VILLAGE OF CALEDONIA UTILITY DISTRICT MEETING AGENDA

Wednesday, June 5, 2024 – 6:00 p.m.

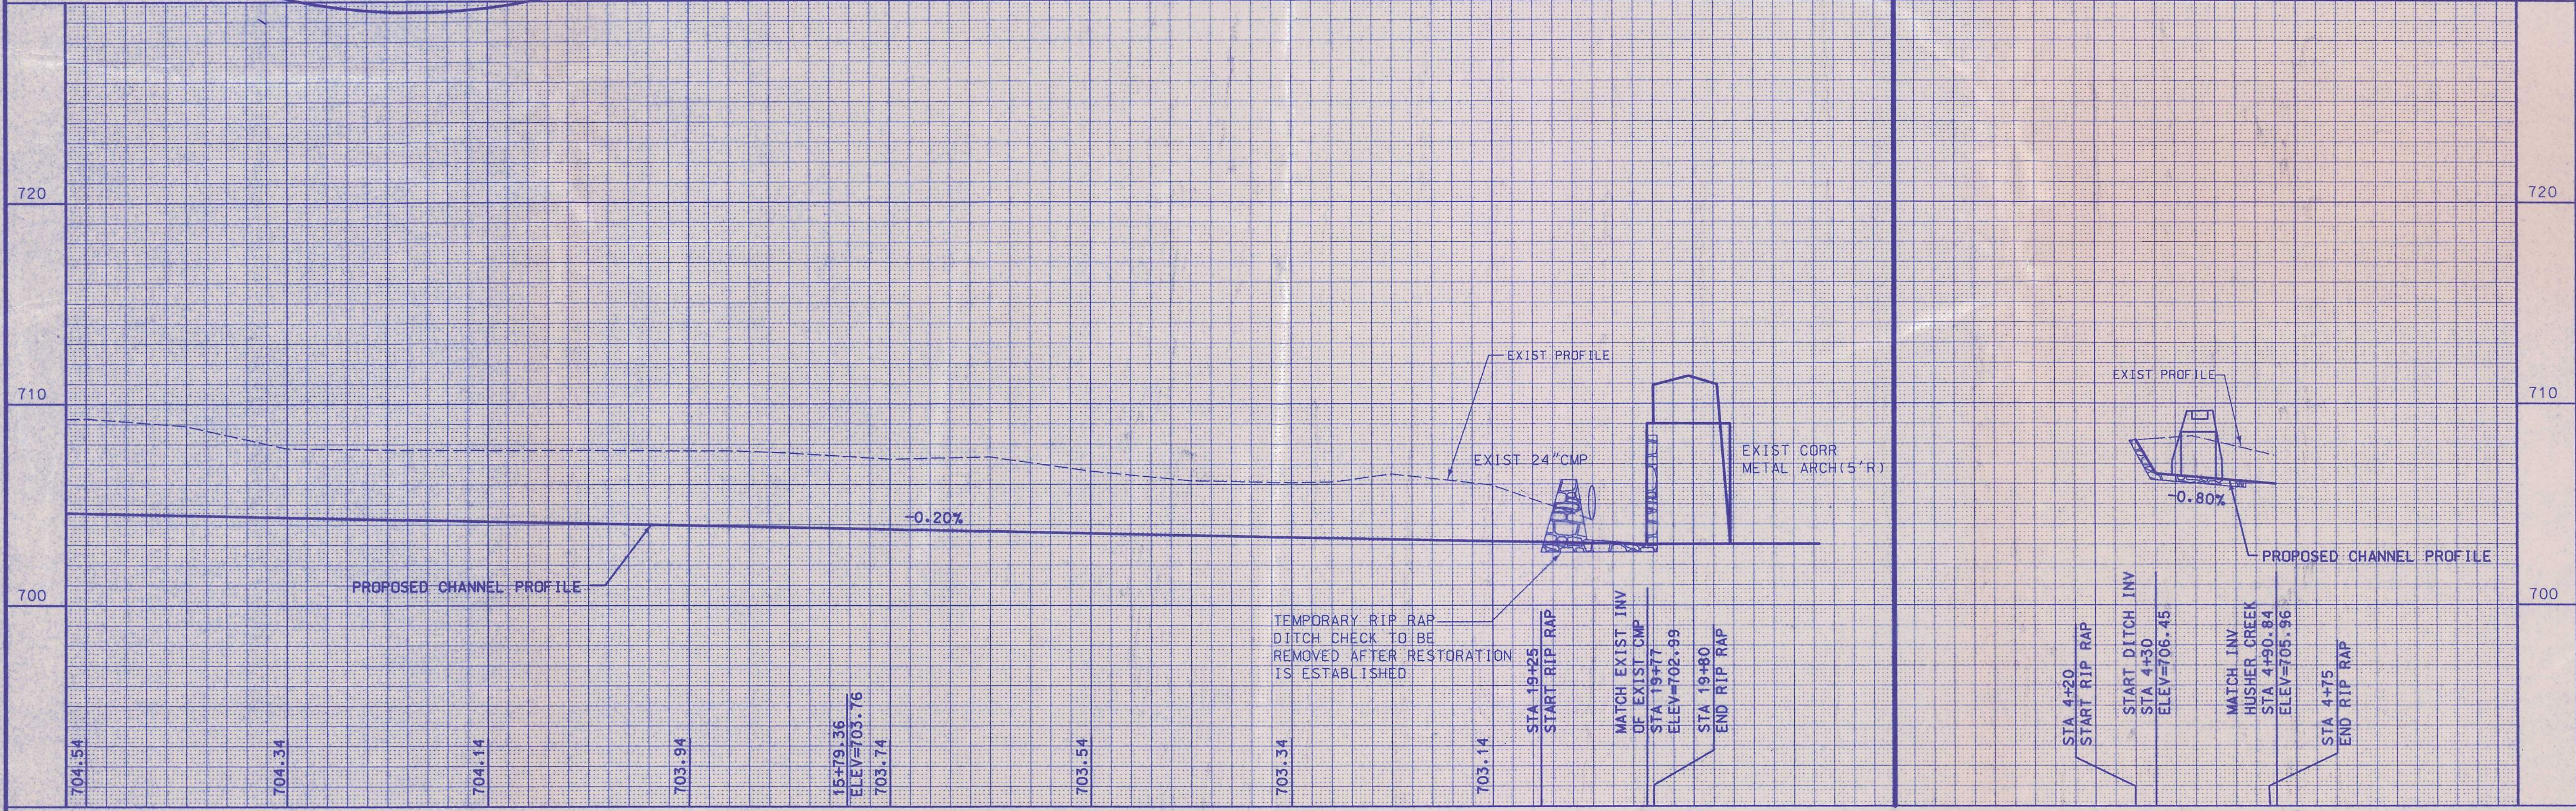
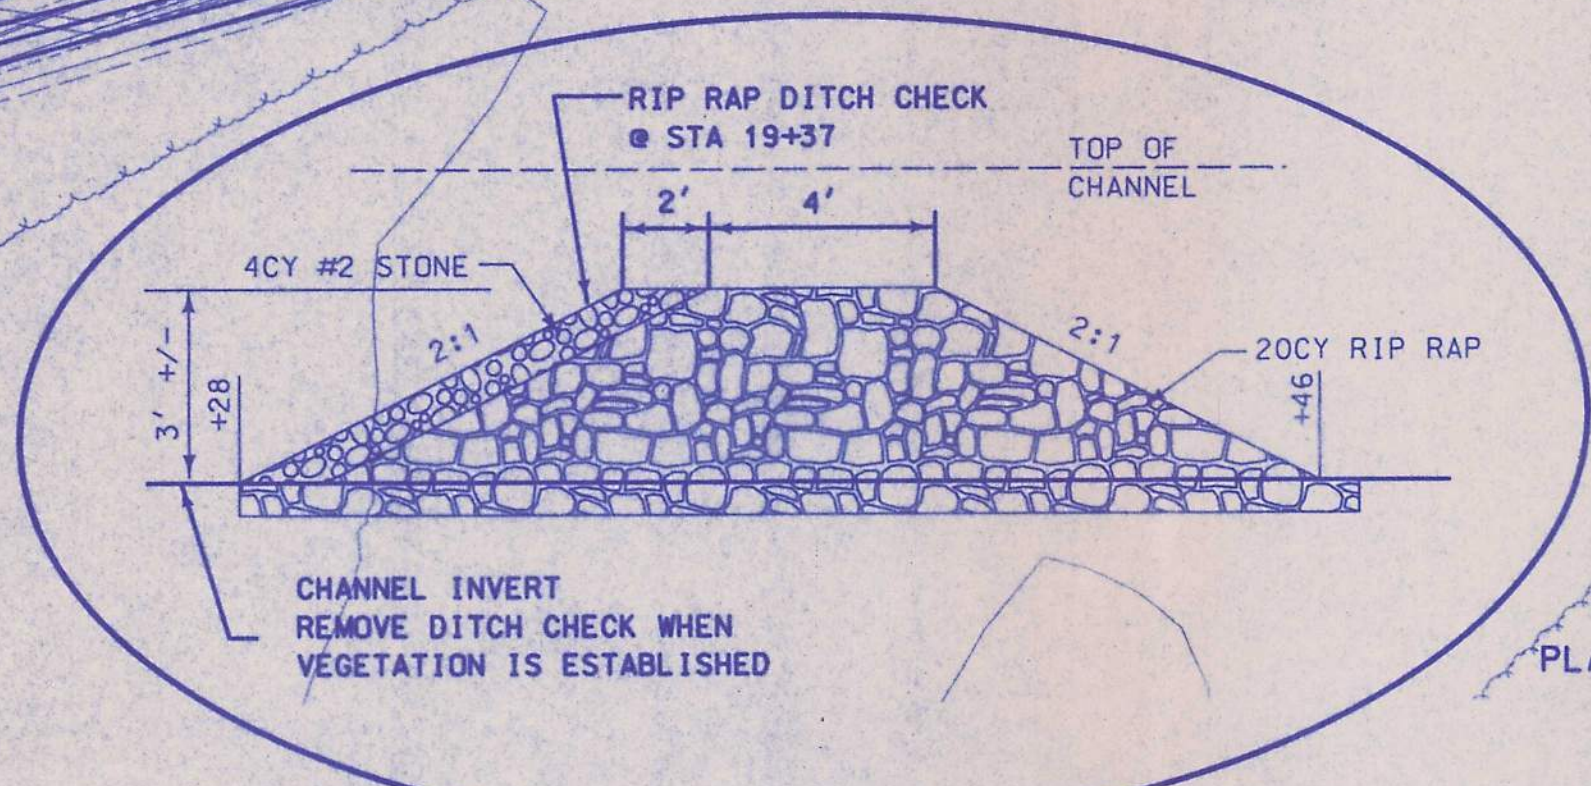
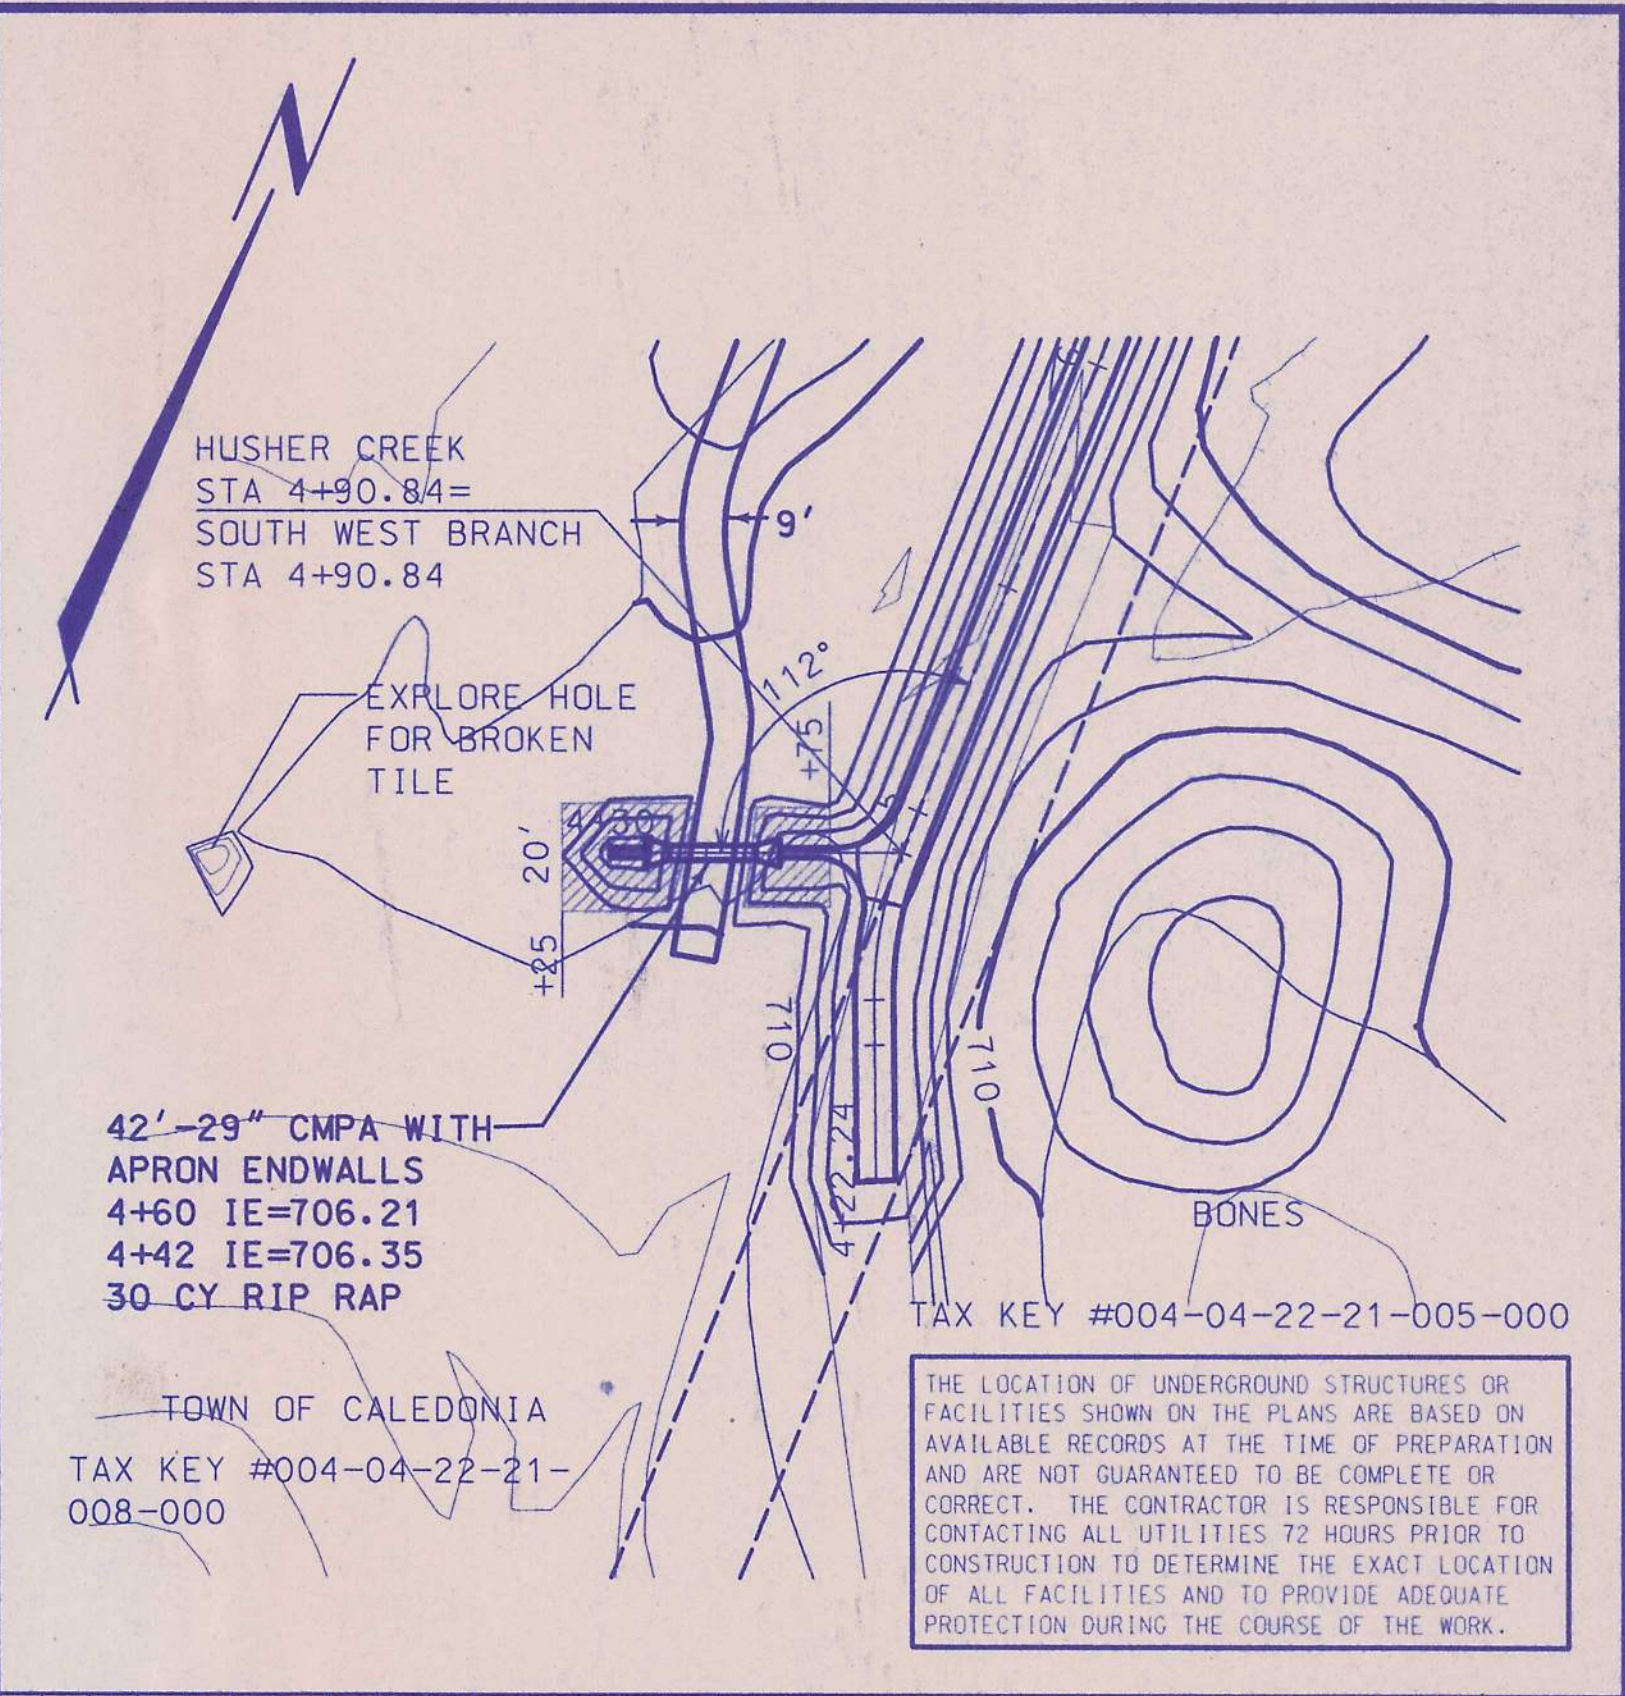
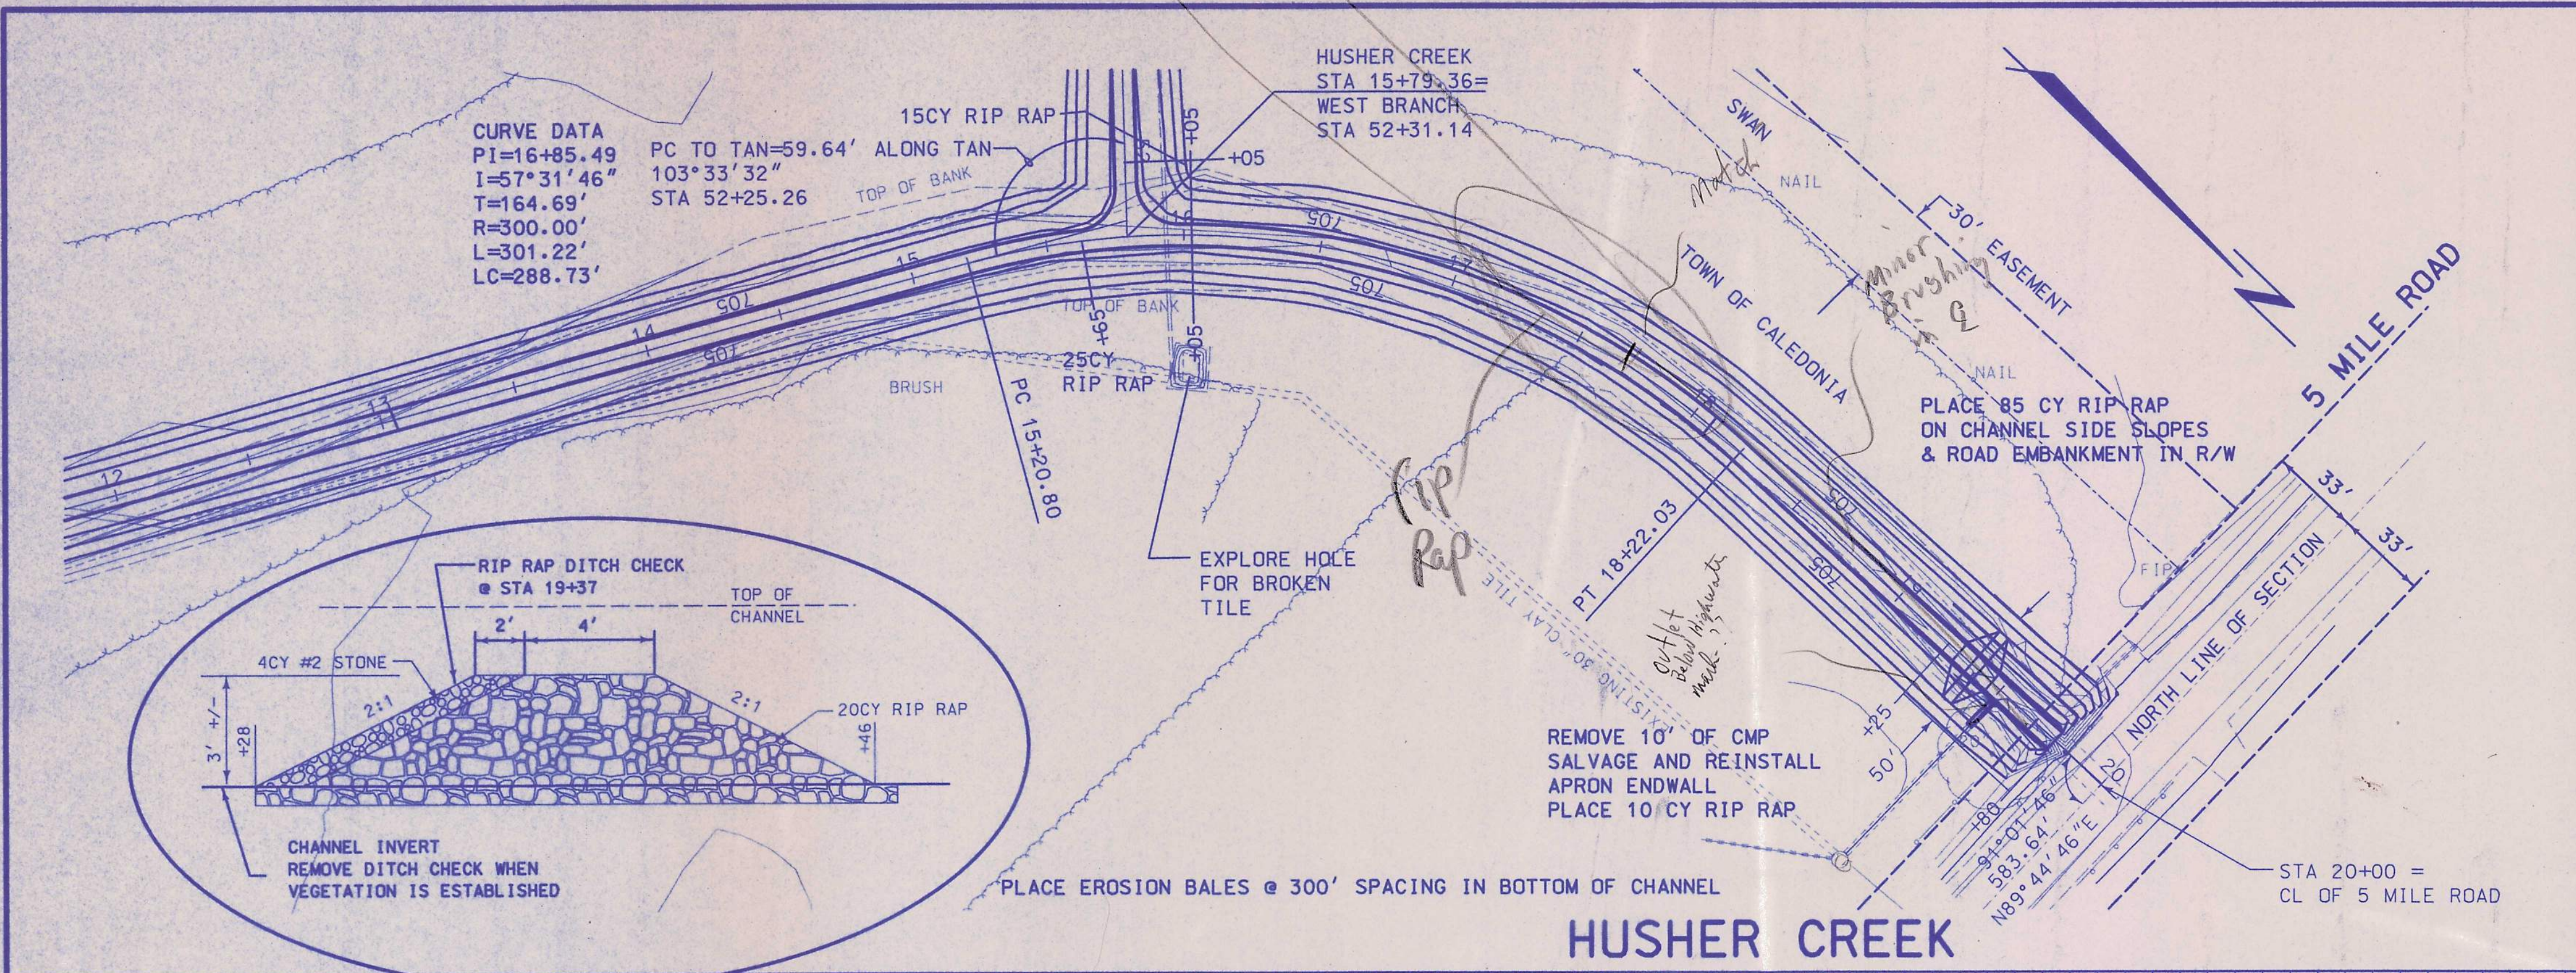
NO.	REVISIONS	BY	DATE	DRAWN BY:	DESIGNED BY
				PRELIM	WDS
				FINAL	CHECKED BY
				SRH	
				DATE	SCALE
				FEBRUARY, 1998	HORZ: 1"=40' VERT: 1"=4'
ALL RIGHTS RESERVED				REVISED TO CONFORM TO CONSTRUCTION RECORDS DATE
